# Work Order ID 56395

Item Name: Basket Hoop

DRAWING NO. D3166	TITLE BASKET HOOP	REV A1	<b>DART AEROSPACE LTD ENGINEERING ORDER</b>		D.E.O. NO. D3166-A-2	SHEET NO. 1 OF 1	SCALE NTS
DRAWN AJS		CHECKED L	MFG. APPR. M		APPROVED MD	DE APPR. H	
DATE 08.12.11		DATE 08.12.15	DATE 08/12/15		DATE 08/12/16	DATE 08.12.16

DESIGN #	DRAWN BY CP	DART AEROSPACE LTD HAWKESBURY, ONTARIO, CANADA	
CHECKED #	APPROVED #	DRAWING NO. D3166	REV. A SHEET 1 OF 1
DATE 02.07.10		TITLE BASKET HOOP	SCALE NTS
A	02.07.10	NEW ISSUE	
A1	04.04.08	38+/-1 WAS 36.0

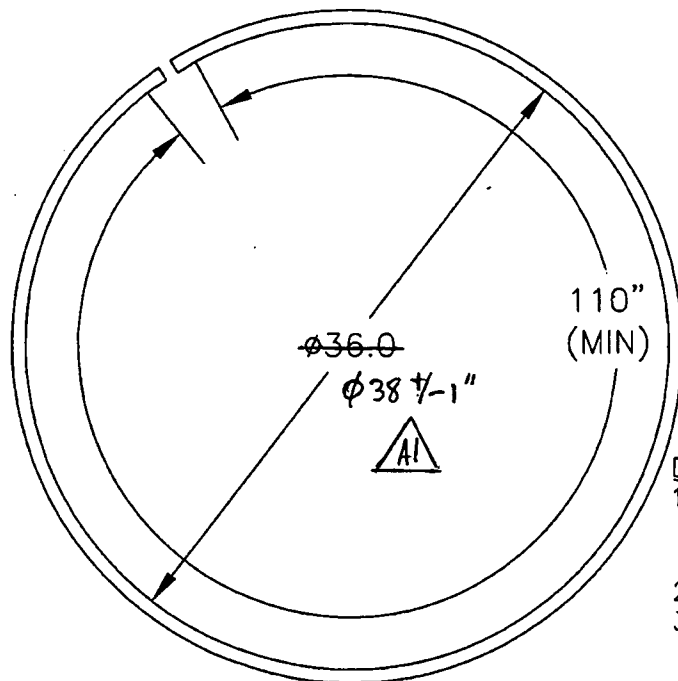
1) MODIFY MATERIAL NOTE FOR D3166-1 AS SHOWN:

WAS:

- 1) MATERIAL: AISI 304/316 SS SQUARE TUBING,  
0.75" x 0.75" x 0.063 WALL, 60.00" LONG  
(REF DART SPEC. M304TS0.750W.063)

2) MODIFY MATERIAL NOTE FOR D3166-3 AS SHOWN:

WAS:

- 1) MATERIAL: AISI 304/316 SS SQUARE TUBING,  
0.75" x 0.75" x 0.063 WALL, 120.00" LONG  
(REF DART SPEC. M304TS0.750W.063)

REASON: SEE PAR 08-005

IS:

- 1) MATERIAL: AISI 304/316 SS, 3/4 X 3/4 X 0.065 WALL SQUARE TUBING,  
60.00" LONG  
REF. DART SPEC M304TS0.750W.065

IS:

- 1) MATERIAL: AISI 304/316 SS, 3/4 X 3/4 X 0.065 WALL SQUARE TUBING,  
120.00" LONG  
REF. DART SPEC M304TS0.750W.065
